# RD250A/350A

## CARBURETOR MODIFICATION

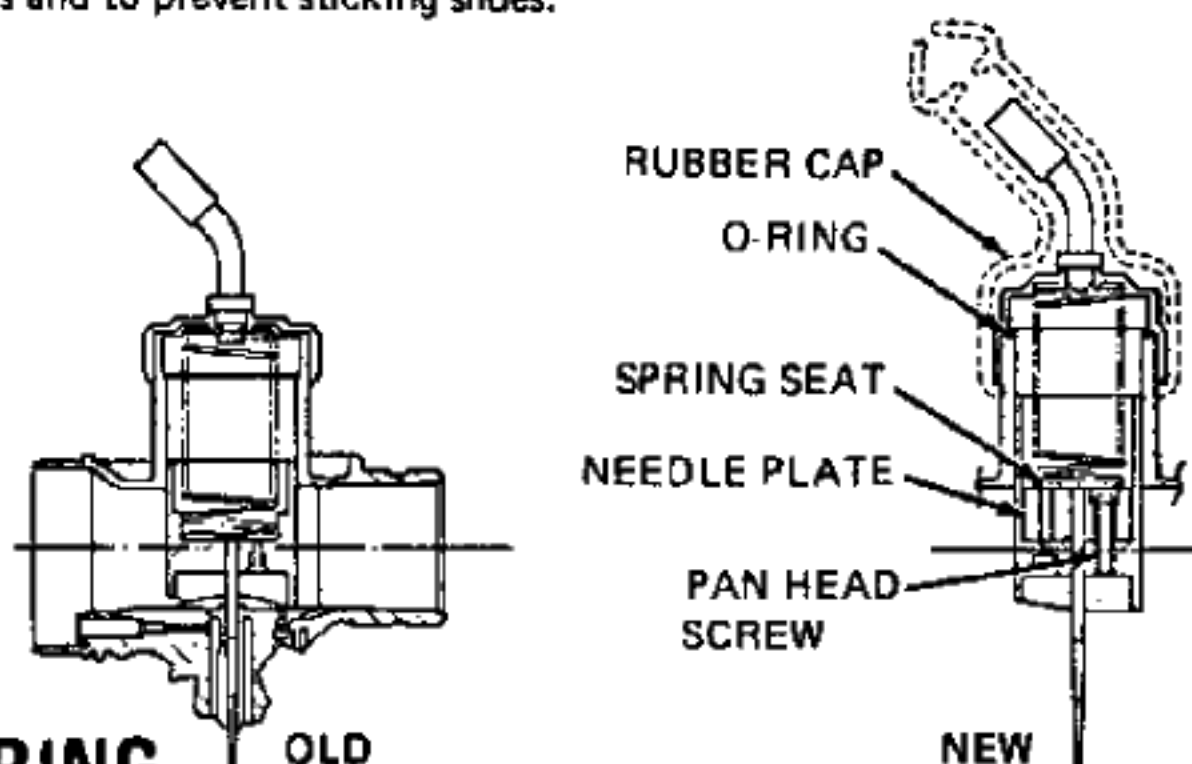
The following modifications have been devised by the factory to improve the waterproof qualities of the carburetors and to prevent sticking slides.

NEW PART NO.	DESCRIPTION	PRICE	REMARKS
<b>RD250A</b>			
361-14101-02-00	CARBURETOR ASSY. (L)		New I.D. Mark 36102
361-14102-02-00	CARBURETOR ASSY. (R)		
<b>RD350A</b>			
360-14101-02-00	CARBURETOR ASSY. (L)		New I.D. Mark 36002
360-14102-02-00	CARBURETOR ASSY. (R)		
<b>RD250A/350A</b>			
361-14112-25-00	THROTTLE VALVE (L)		
361-14113-25-00	THROTTLE VALVE (R)		
401-14936-00-00	SEAT, spring		
361-14946-00-00	PLATE, needle set		Addition
97602-03120-00	PANHEAD SCREW		Addition
92902-03100-00	WASHER, spring		Addition
360-14158-00-33	TOP, mixing chamber		
361-14147-00-00	O-RING		Addition
360-26329-01-00	CAP, rubber
